<u>MEETING</u> CHIPPING BARNET AREA COMMITTEE
<u>DATE AND TIME</u> MONDAY 19TH FEBRUARY, 2018 AT 7.00 PM
<u>VENUE</u> HENDON TOWN HALL. NW4 4BG

Title	Review of the Barnet Hospital Area Statutory Parking Consultation
Report of	Strategic Director for Environment
Wards	Underhill and High Barnet
Status	Public
Enclosures	<p>Appendix A –</p> <p>Drawing No. SCR191-2a - Proposed CPZ - Granville Road and Argyle Road EN5 (revised)</p> <p>Drawing No.SCR191-3a - Proposed CPZ – Elmbank Avenue, Garthland Drive, Vyse Close, Wellhouse Lane and Wellside Close EN5 (revised)</p> <p>Drawing No.SCR191 – 4a Proposed CPZ - Lingholm Way, Lexington Way and Sutton Crescent EN5 (revised)</p> <p>Drawing No.SCR191-5 - Galley Lane and Barnet Road</p> <p>Drawing No.SCR191-6 - Trinder Road, Well Road and Well Approach</p> <p>Drawing No.SCR191-7 - Bells Hill and Spring Close , St Stephen Road and Redwood Way</p> <p>Drawing No.SCR191-8 - Aitken Road, Denton Close, North Close, Escot Way and Endersby Road</p> <p>Drawing No.SCR191-9 - Kings Road and Cavendish Road</p> <p>Drawing No.SCR191-10 - Kings Road and Grimsdyke Road</p> <p>Drawing No. SCR191-11 - Bells Hill and Dellors Close</p> <p>Drawing No.SCR191-12 and SC

DRAWING NO:
SCR191-3a

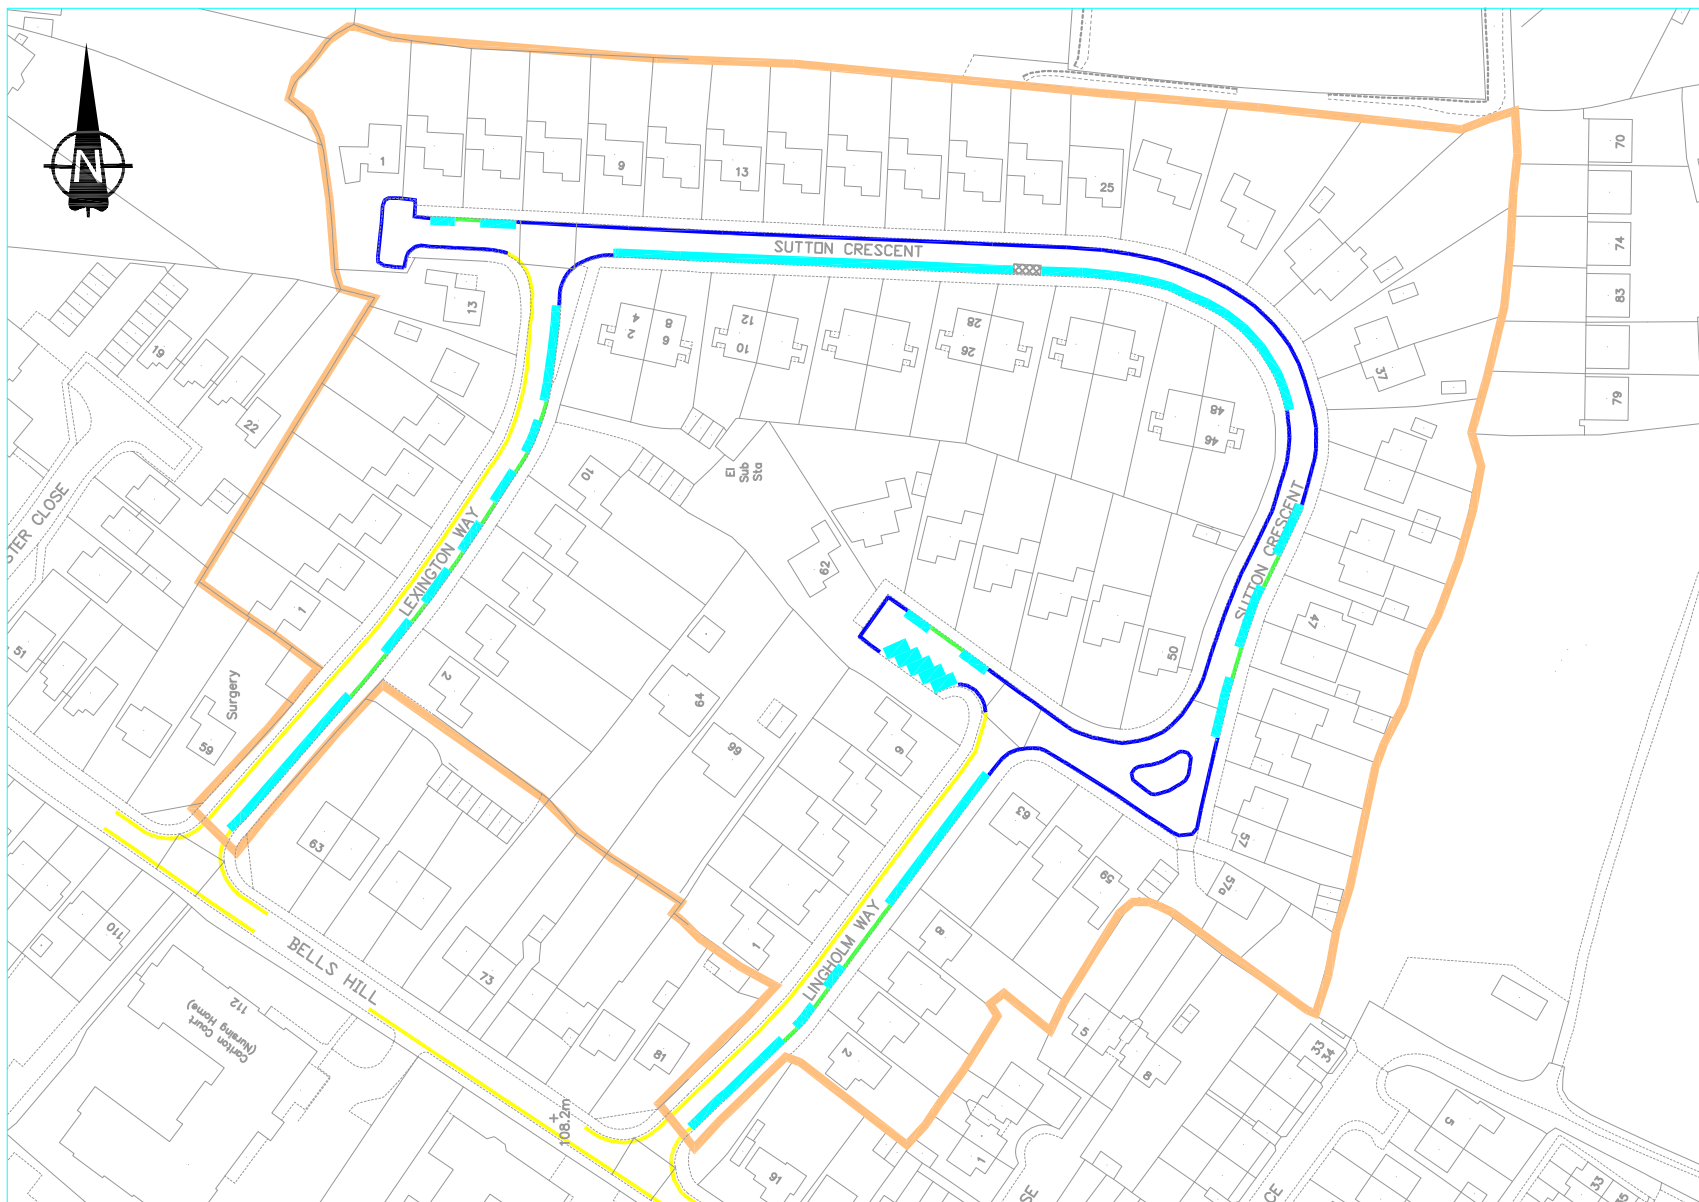
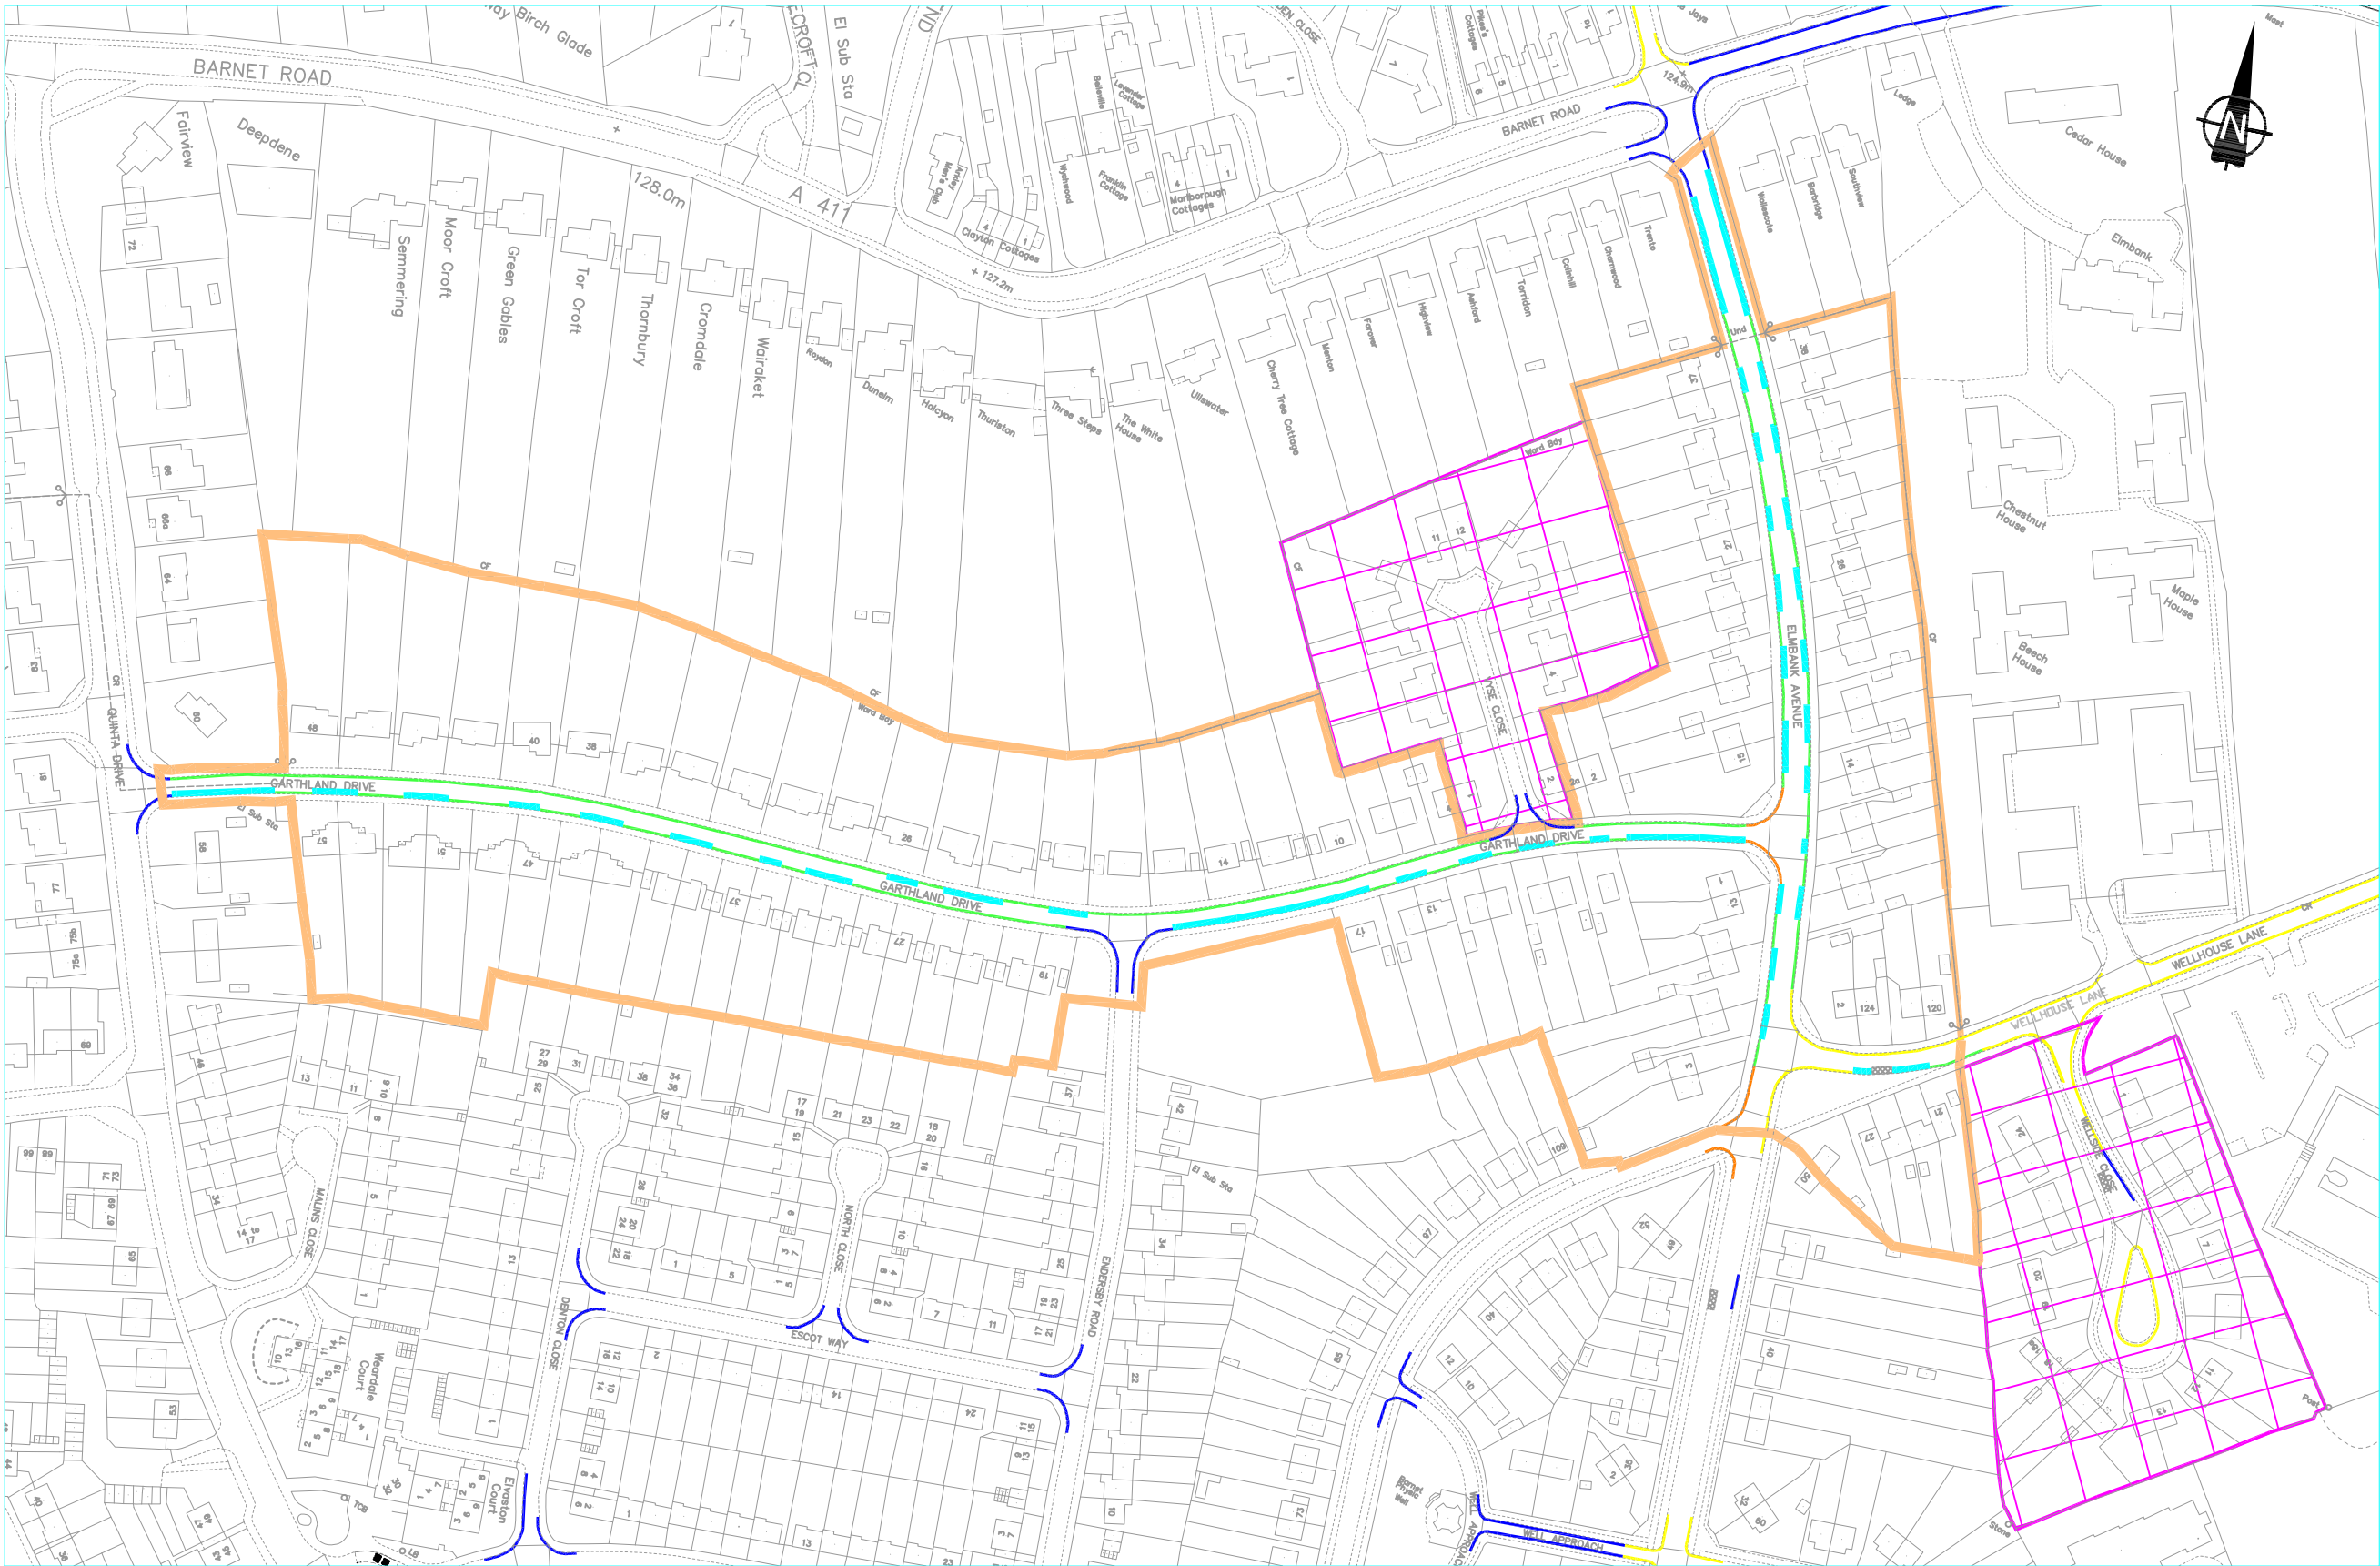
- Two residents of Garthland Drive requested for the proposed resident permit holders only parking bay outside their homes to be removed in order to accommodate the existence of vehicle dropped kerb which will allow access to park off street on their hardstanding's.
- Four residents of Garthland Drive within the proposed CPZ were concerned about the length of the hours of control and the CPZ operating on a Saturday.
- Two residents were concerned about parking bays on both sides of the Elmbank Avenue due to the narrow width of this section of road.

1.13.7 There was a request that consideration should be given to introducing footway parking in Vyse Close.

- 2.15 Due to the Council's changing policy in respect of footway parking, it is considered that the proposed parking arrangements in Vyse Close should be modified from a "Past this point" arrangement, to a traditional CPZ layout with marked out parking bays and signage, albeit on the footway.

- 2.16 Furthermore it is considered that a length of proposed resident parking bay outside No. 1 Garthland Drive is reduced in length to take into the account the existence of a vehicular dropped kerb (Crossover)
- 2.17 It is considered that the proposal should be implemented albeit with minor modifications as outlined above and as shown on plan SCR191-3a.

- a. That the proposed resident parking bay outside No. 1 Garthland Drive is reduced in length to take into the account the existence of a vehicle crossover – Drawing No.SCR191-3a.**

- e. That an additional parking place should be provided on Sutton Crescent outside No. 55 and No.57 Sutton Crescent. – Drawing No.SCR191-4a.**
 - f. That footway parking in Vyse Close is considered as an alternative to the proposed “Past this point” parking layout.**
